IN THE DRAWINGS

REMARKS

**FIG. 1**

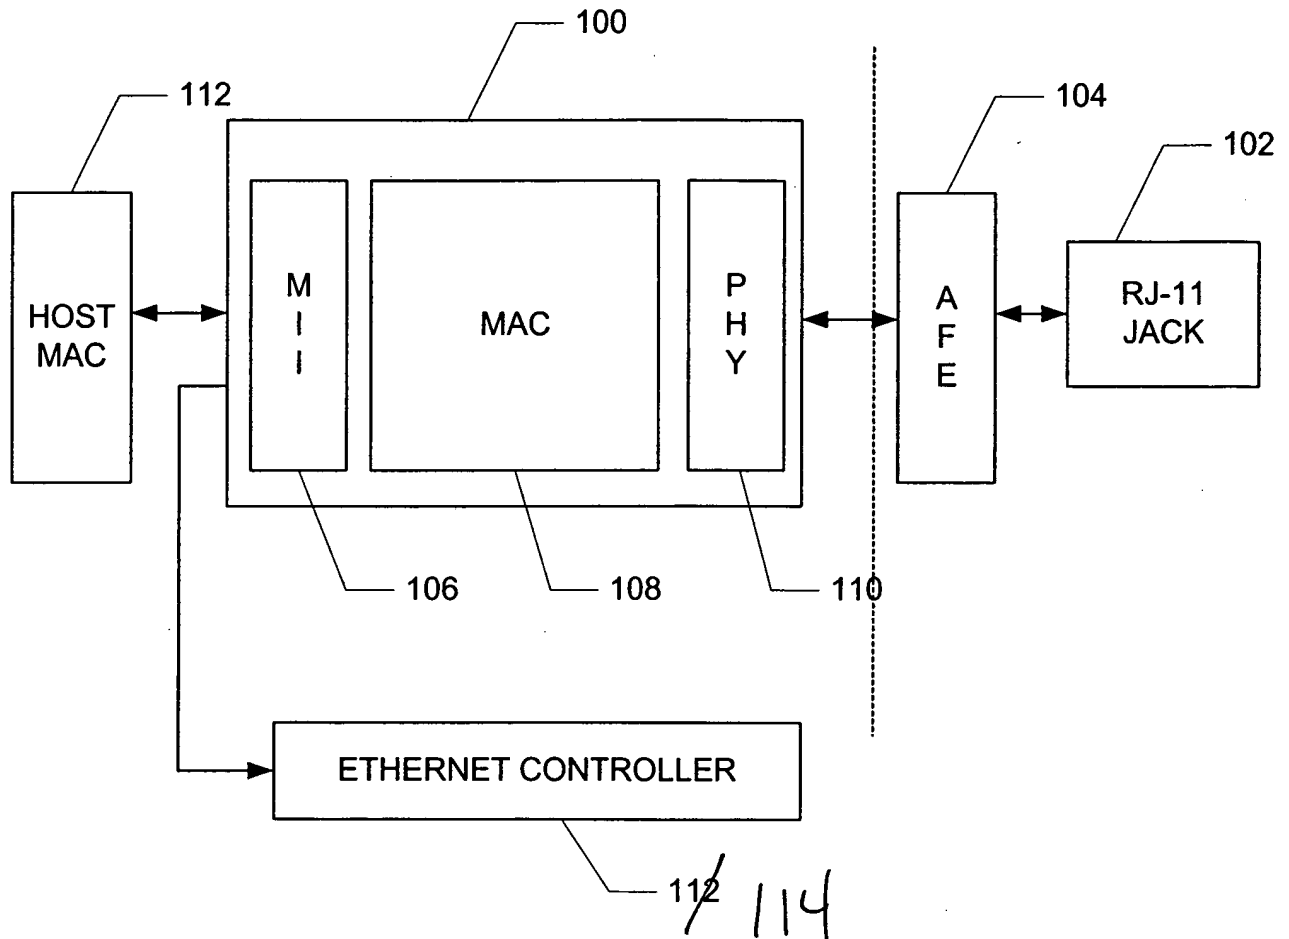
The attached sheet of drawings include changes to Figure 1. This sheet replaces the original sheet of Figure 1. Applicants have added the label of "114" on Figure 1 to identify the element of "Ethernet Controller." Applicants have attached herewith an annotated sheet showing this change to Figure 1 as well as a replacement sheet for Figure 1.

The Examiner has further objected to the drawings because reference character "112" has been used to designate both the Host MAC as well as the Ethernet Controller. Paper No. 5, page 3. Applicants have amended Figure 1 to label Ethernet Controller 114 as well as amended the Specification accordingly.
